**Cape Breton Development Corporation
Victoria Junction Tailings Basin
Review of Dam Safety Findings**

ADI Limited
Report: L1573-048.1
Date: January 2010

ADI Quality System Checks	
Project No.: L1573-048.1	Date: 2010.Jan.22
Issue Status: Draft	Revision No.: 1
Prepared By: Fred Baechler, M.Sc., P.Geo. Ed Carey, P.Eng., BGC Engineering Inc.	
Reviewed By: Brian Latimer, P.Eng.

Project Title	
VJ TAILINGS BASIN CLOSE OUT PROJECT	
Dwg. Title	
OVERVIEW OF TAILINGS BASIN & ASSOCIATED INFRASTRUCTURE	
Project No.	1573-048.1
Dwg. No.	FIGURE T-1
Rev. No.	0
Scale	1:4000
This drawing is not to be scaled

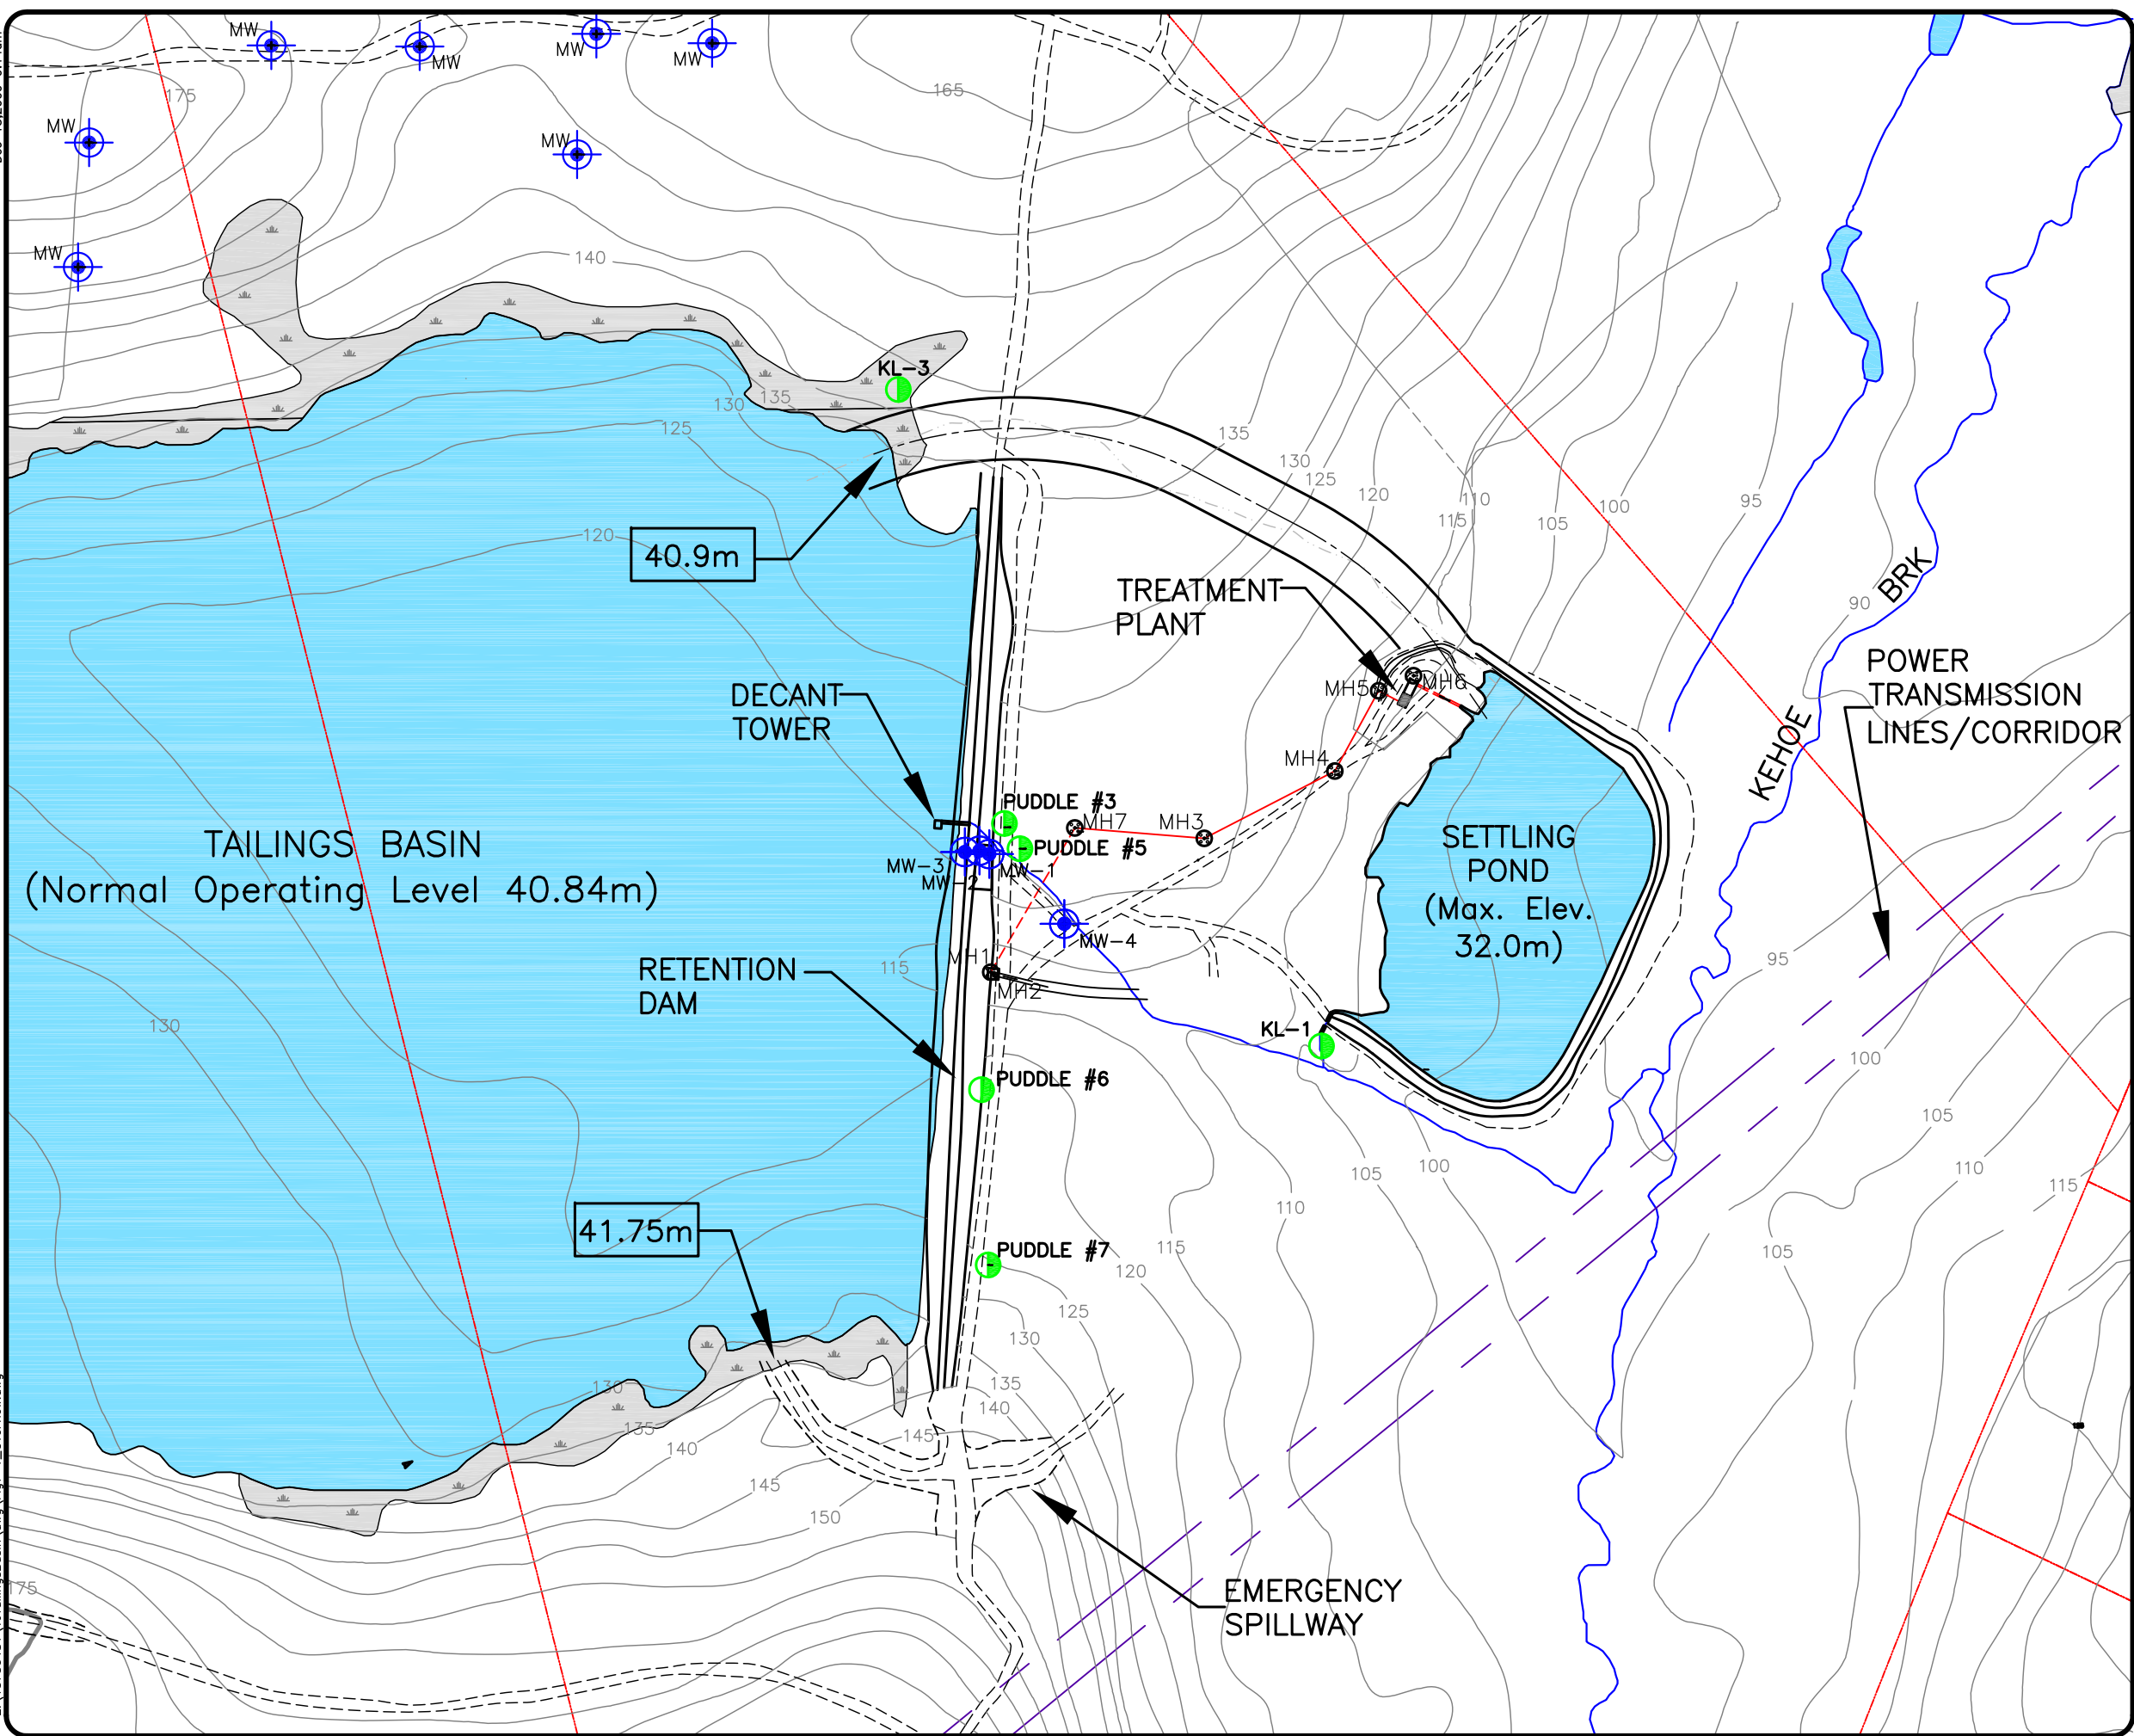
Three monitoring wells were installed in 2004 to allow monitoring of the groundwater level measurements to be taken, as recommended by ADI (1998) and JWA (2003). Two of these monitoring wells contain screened sections extending beyond the contact between the glacial till and bedrock, the third monitoring well extends into the glacial till layer. The 2008 AMEC Dam Safety Review reports high water levels in the monitoring wells, approximately 0.4 metres to 1.2 metres above the contact between the native till and the embankment fill. The locations of the monitoring wells (MW1, MW2 and MW3) are shown on Figure T-1 (Inset).

The phreatic level, as estimated by the water levels measured in the monitoring wells, is higher than should be expected. The measured levels may or may not be reflective of the actual groundwater conditions in the embankment. It is possible that because the wells have been installed into the bedrock, flow or pressure in the bedrock have caused the water level readings to be higher than the actual groundwater level throughout the embankment. BGC/ADI recommends that three new monitoring wells be installed, limiting the depth of the screened section to within the embankment fill.

Site inspections conducted by AMEC (2008) and ADI/BGC (October 2009) have revealed surcharged or artesian pressures in each of the manhole components of the pipe system connected to the toe drain. The water levels are shown in Table 4-1. In June 2009, AMEC conducted a pump test at Manhole 1 (MH1), the first access point downstream of the toe of the dam (Figure T-1). The pump test results showed flow rates of 200 gpm to 400 gpm. Without having the benefit of water level measurements taken in the manholes before and after the pump test, it is inferred that the high flow rates are not necessarily indicative of seepage rate through the dam because it is probable that a high percentage of the pumped volume may have been withdrawn from the piping system and manholes downstream of the pump test location.

Project Title	
VJ TAILINGS BASIN CLOSE-OUT PROJECT	
Dwg. Title	
PROFILE THROUGH MONITORING WELLS & MAN HOLES	
Project No.	L1573-048.1
Dwg. No.	T-2
Rev. No.	0
Scale	AS SHOWN <small>This drawing is not to be scaled</small>

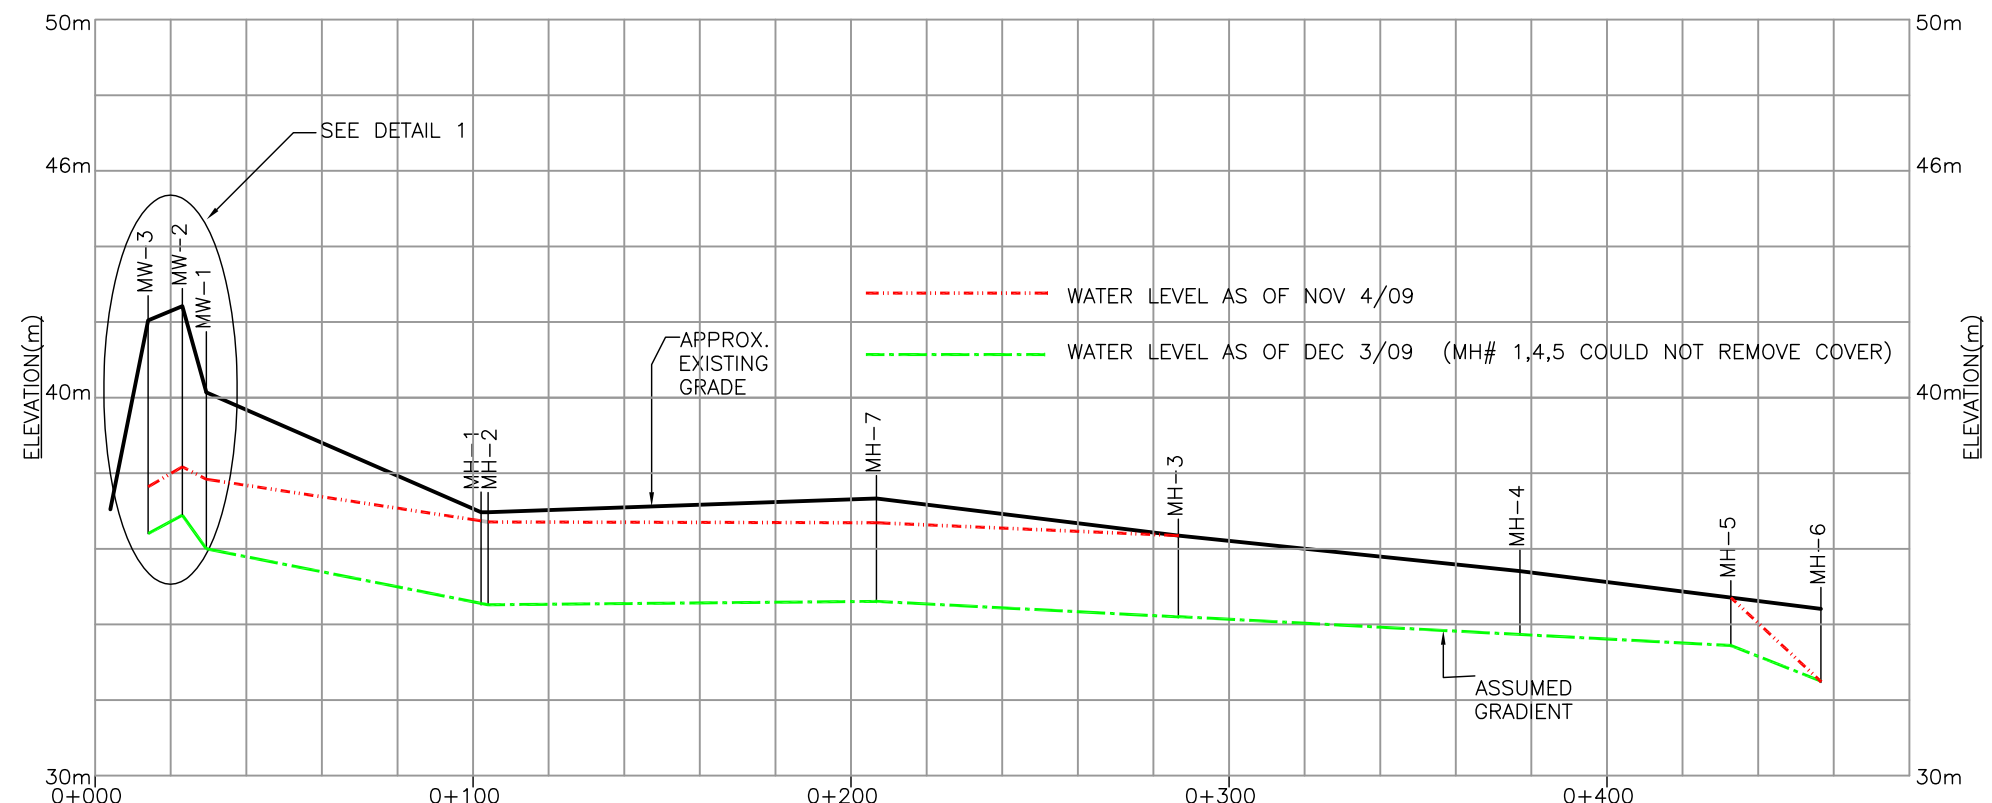
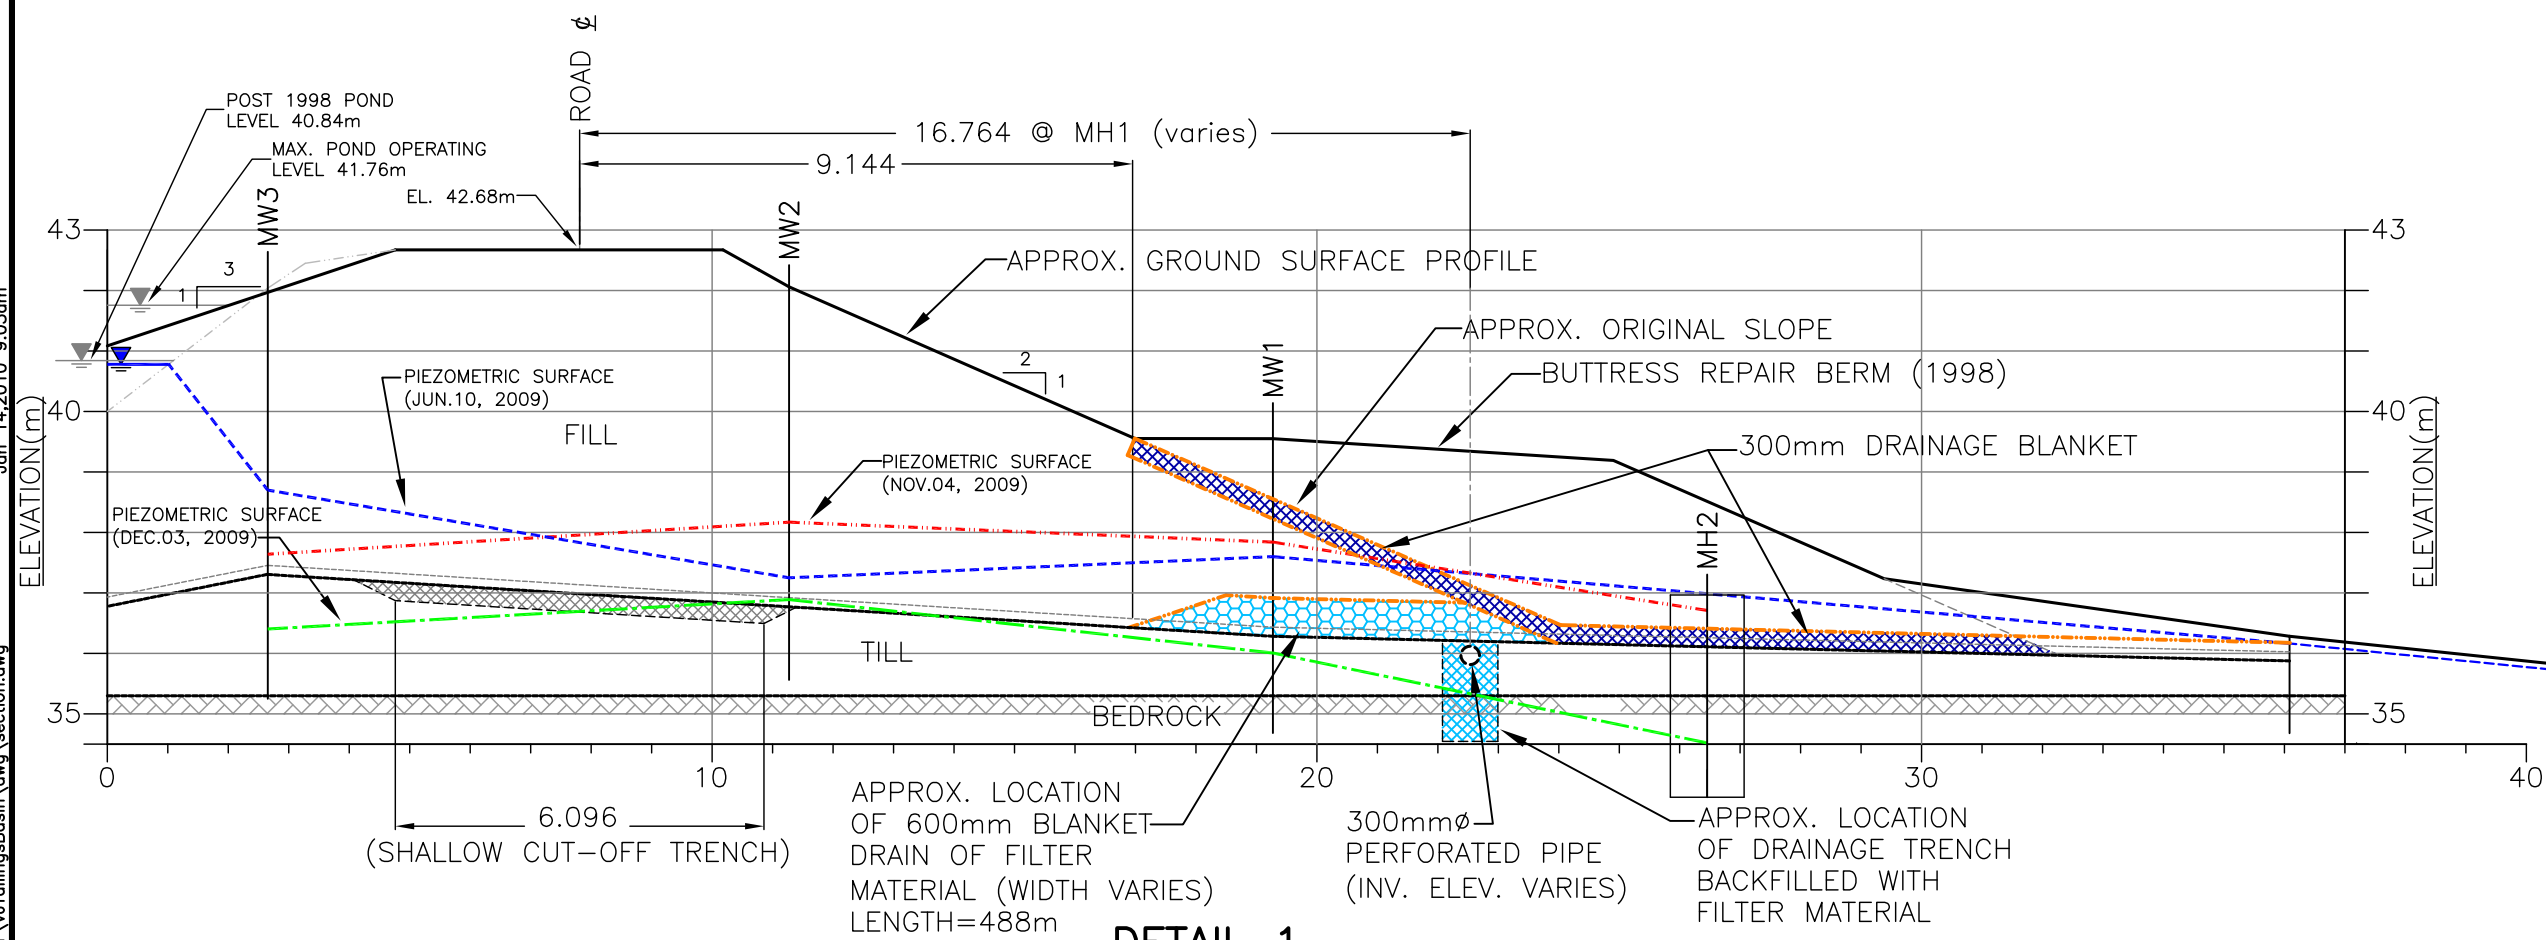
As noted in Table 4-1, the water levels in the monitoring wells have dropped between 1.2 to 1.8 metres since the blockage in the manhole piping system was removed in November 2009. As well, the manhole water levels have typically decreased by more than 2 metres.

Prior to the removal of the blocked pipe discharge, the water levels measured at the drainage blanket in monitoring well (MW1) was 37.9 metres. The water level in MH2, immediately downstream of the drainage blanket, was 36.7 metres.

Following removal of the pipe, the water level in MW1 decreased 1.9 metres to reach elevation 36.0 metres. The level in MH2 decreased 2.2 metres to reach elevation 34.5 metres. These elevations are consistent with the design intent provided by GeoCon in their report of 1983. Also the levels are consistent with the phreatic surfaces assumed for the stability analysis completed in 1998, 2003 and 2008.

As noted in other sections of the report, the satisfactory performance of the drainage blanket must be confirmed in the future. This can be accomplished by:

- Video inspection of the perforated drainage pipe (300 mm) in the collection trench.
- Installation of additional vibrating wire pneumatic piezometers in the dam structure.
- Installation of standpipe piezometers downstream of the dam.
- Annual inspections of the drainage system.
